Access Compliance Report

Public Rights-of-Way

Intersection ID: 10025569	Main Street: E_W_T_HARRIS_BV	Cross Street: N/A	Location: NE
ADA ID: 0E40925CB04E	Ramp Type: PerpDiag	Initial Pass/Fail: Fail	Overall Compliance: No
Severity Score: 13.75			
Codes/Mitigation Info/Possible Solution		Field Measurements/Component Compliance

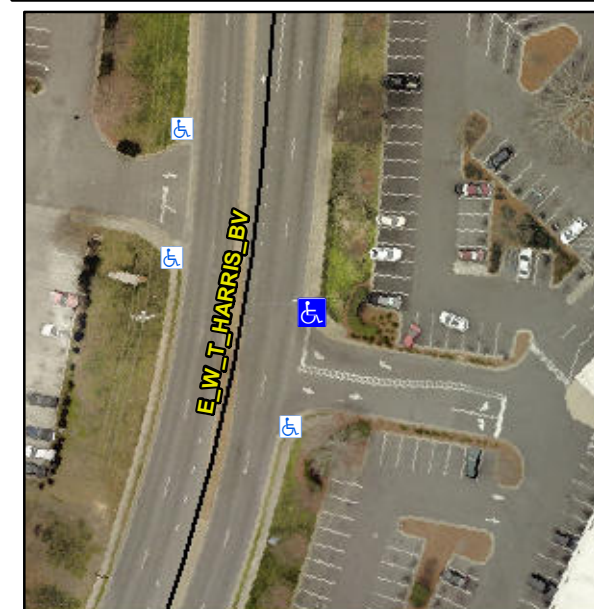
Not Found, R304.2.2, R304.5.3

Compliance	Description	Data	Compliance	Description	Data
N/A	Ramp Length (in)	70.0	No	Ramp Slope (%)	9.2
Yes	Ramp Width (in)	48.0	No	Ramp XSlope (%)	2.7
N/A	Flare Type LT	N/A	N/A	Flare Type RT	N/A
N/A	Flare Slope LT (%)	N/A	N/A	Flare Slope RT (%)	N/A
N/A	Flare Traversable LT?	N/A	N/A	Flare Traversable RT?	N/A
N/A	Landing Length (in)	N/A	N/A	DWS Provided?	N/A
N/A	Landing Width (in)	N/A	N/A	DWS Contrast?	N/A
N/A	Landing Slope (%)	N/A	N/A	DWS Length (in)	N/A
N/A	Landing X Slope (%)	N/A	N/A	DWS Full Width?	N/A
N/A	Landing Curb? (Y/N)	N/A	N/A	DWS Offset (in)	N/A
N/A	Shared Landing?	N/A			
N/A	Gutter Ponding?	N/A	N/A	Gutter Slope (%)	N/A
N/A	Gutter Lip Ht (in)	N/A	N/A	Gutter X Slope (%)	N/A
N/A	Painted X Walk1?	No	N/A	Painted X Walk2?	No
	X Walk 1 Direction	To NW		X Walk 2 Direction	To SW
N/A	X Walk 1 Width (in)	N/A	N/A	X Walk 2 Width (in)	N/A
	X Walk 1 Slope (%)	5.8		X Walk 2 Slope (%)	3.8
	X Walk 1 X Slope (%)	2.1		X Walk 2 X Slope (%)	4.6

Remove & Replace Curb Ramp With Two New Directional Ramps or Equivalent.
